From: Doris Lee <Doris.Lee@tpp.net.au>
Sent: Tuesday, 21 October 2025 4:35 PM
To: Peter Mangels; Eilish McNab
Cc: Sarah Santamaria
Subject: RE: Fitzgerald & Yorktown - Traffic - Sweep Path

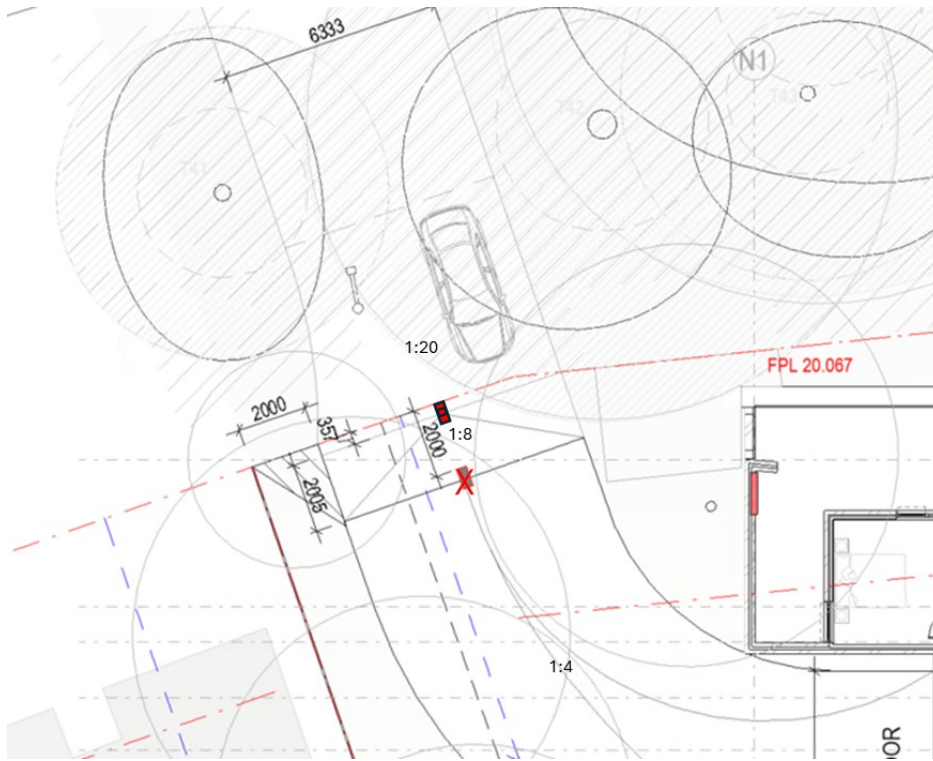
The approved SSDA involves an intercom/ fob reader located outside the site boundary on a 1:20 grade. However, TPP cannot support the retention of the fob reader outside the site boundary in accordance with AS2890.1, despite it being located on a traffic island that sits on a compliant 1:20 grade. Our email on 30 July 2025 suggested it be relocated 2m within the site boundary which is situated in the middle of the **first 4m section** of the 1:8 grade. Refer to the following screenshot for our earlier suggestion for modifying the approved design.

It is understood the proposed design aims to retain the ramp gradients that have been approved in the SSDA as any modifications to the ramp gradients would result in implications on the structural design. Considering the approved ramp gradients will remain unchanged with the first 2m on a 1:8 grade, followed by a 1:4 grade until the bottom of the ramp, we would update our advice to relocate the traffic median and fob reader to the 1:8 grade immediately within the site boundary as shown in the screenshot below. This is not fully compliant to AS2890.1 (2004) Section 3.3 (b) in which requires vehicular control points to have a maximum of 1:20 grade for at least 6m prior to the control point.

TTPP proposes the following justification to the fob reader being located at the immediate start of the 1:8 grade as opposed to the 1:20 grade outside the site boundary:

- Rectification of the fob reader location to be within the site boundary in accordance with AS2890.1 and to avoid any potential liability issues. The suggested location is immediately adjacent to the 1:20 grade which is a workable location based on the approved ramp gradients despite the minor non-compliance.

For pedestrian safety, it is recommended that a bollard be installed at the end of the secondary footpath which is located to the immediate west of the proposed driveway. This is to emphasise termination of the secondary footpath and to deter pedestrian movements across the vehicle queuing area outside the site boundary.
